MEMORANDUM

TO: Madeleine Reinke, Kimley-Horn and Associates, Inc.
FROM: Cynthia Thye, Planner 1
DATE: December 31, 2025
SUBJECT: SP25-119: Lincoln Professional Park L2 - 7 Brews Coffee – Site Plan Review Comments 02

1 EXTERIOR ELEVATION - NORTH
3/8" = 1'-0"

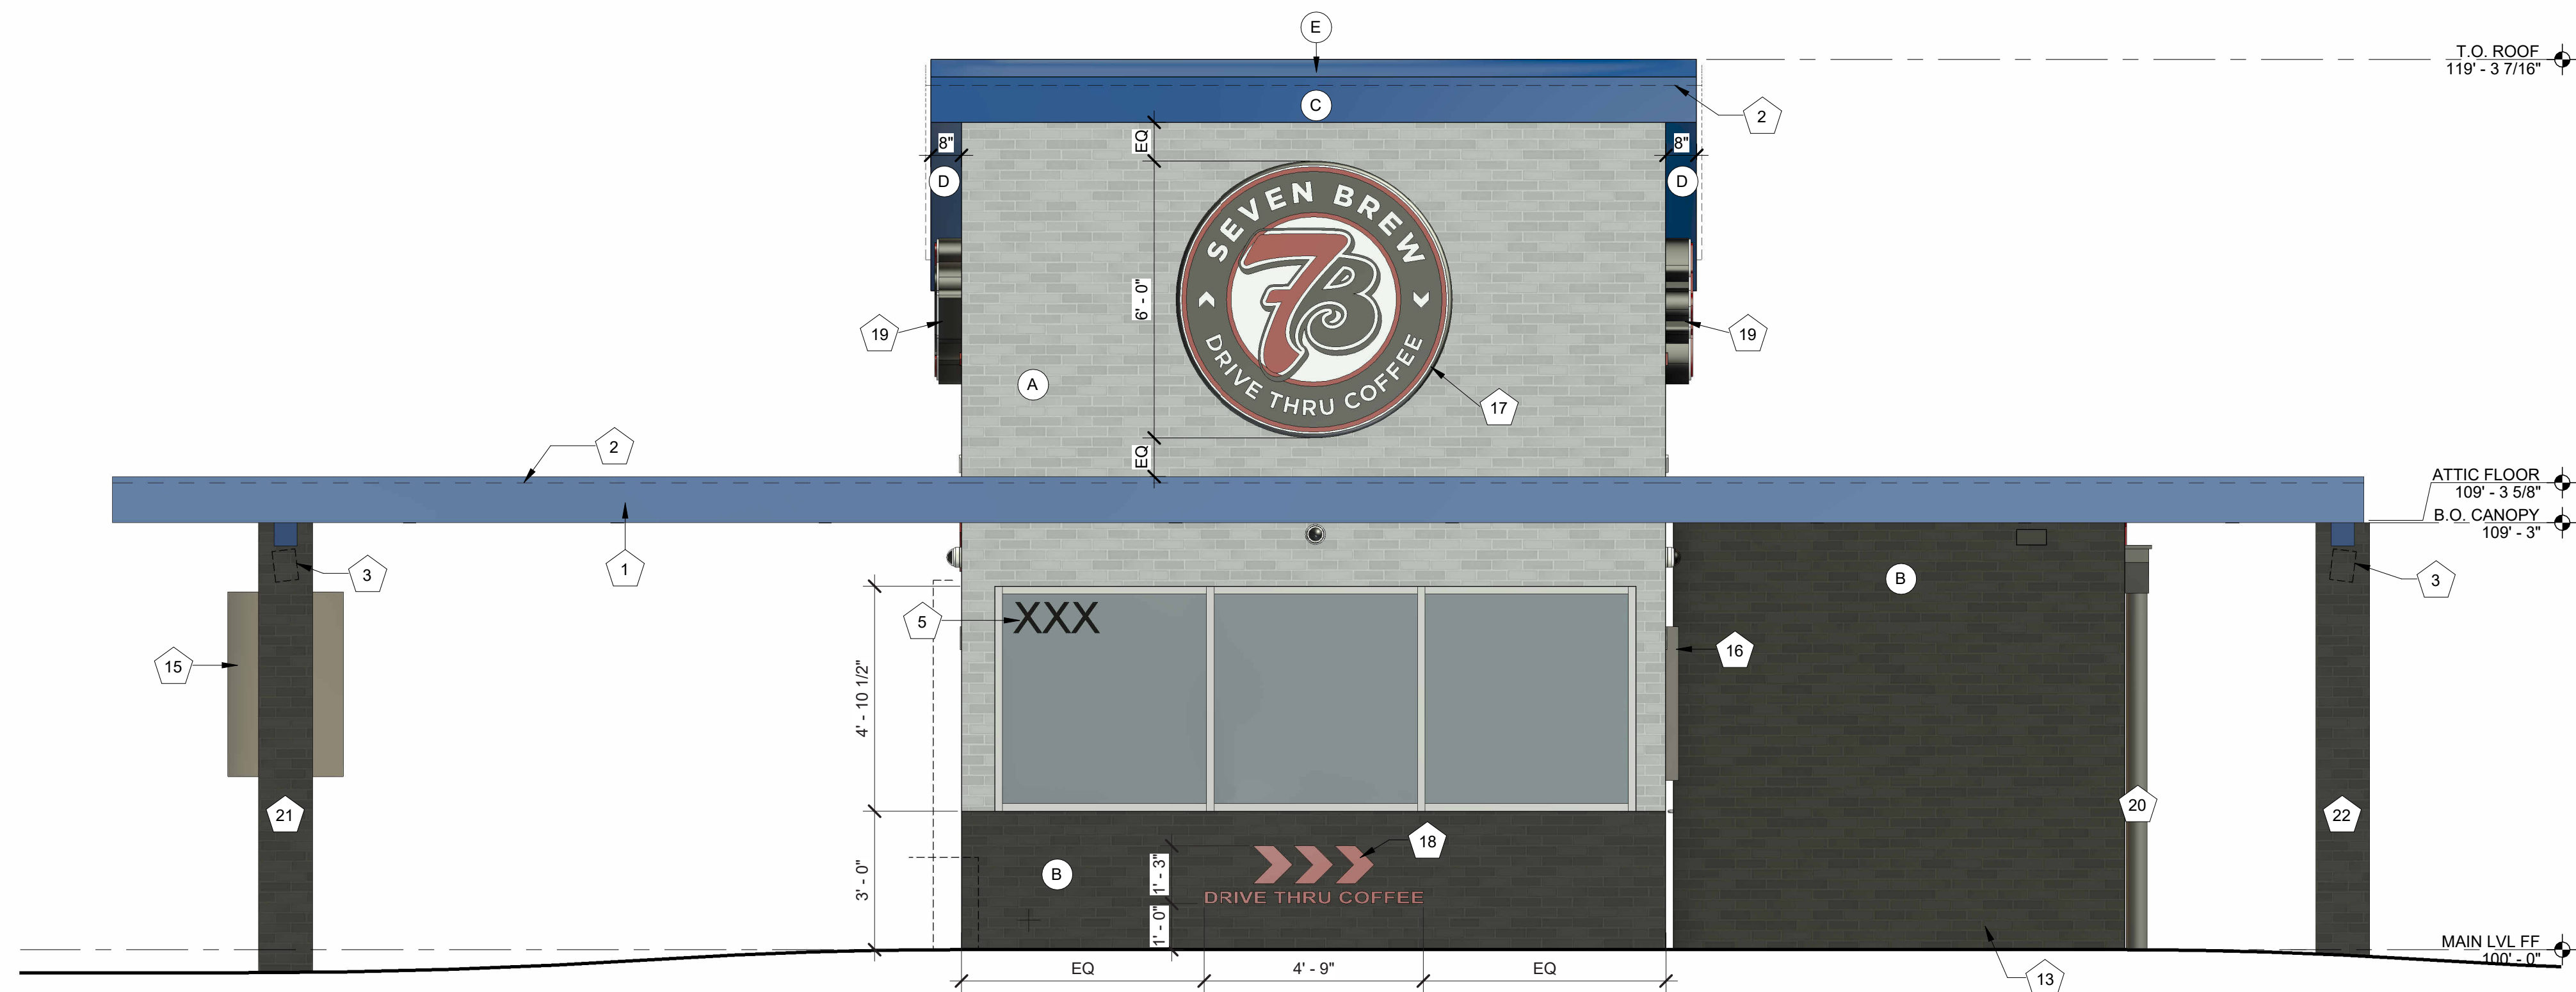
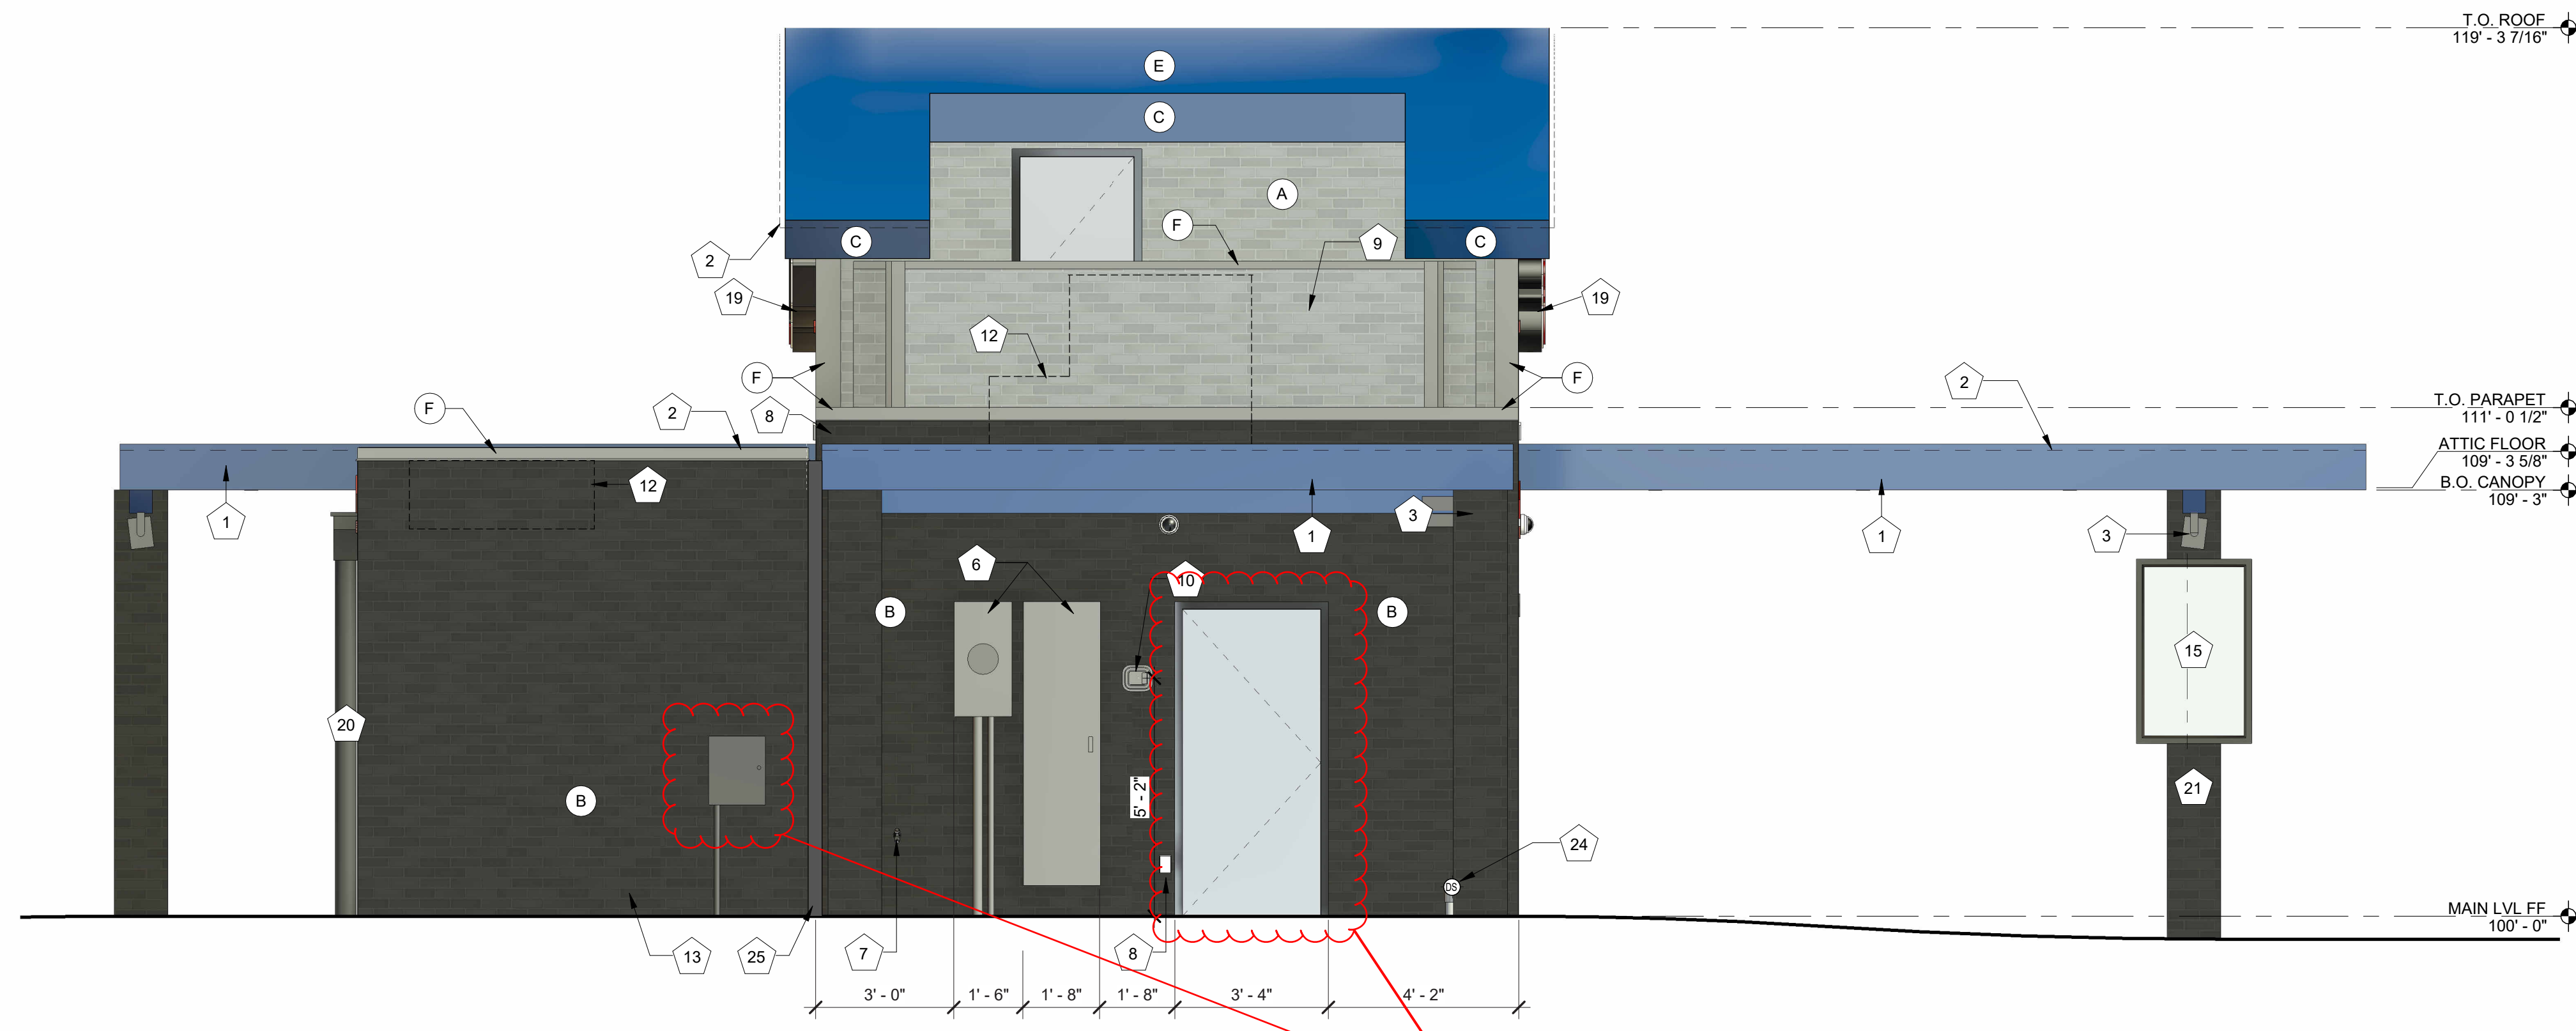
11. Revise Exterior Elevation Materials Legend to include glass and add percentage for each material.

Add Glass to Legend
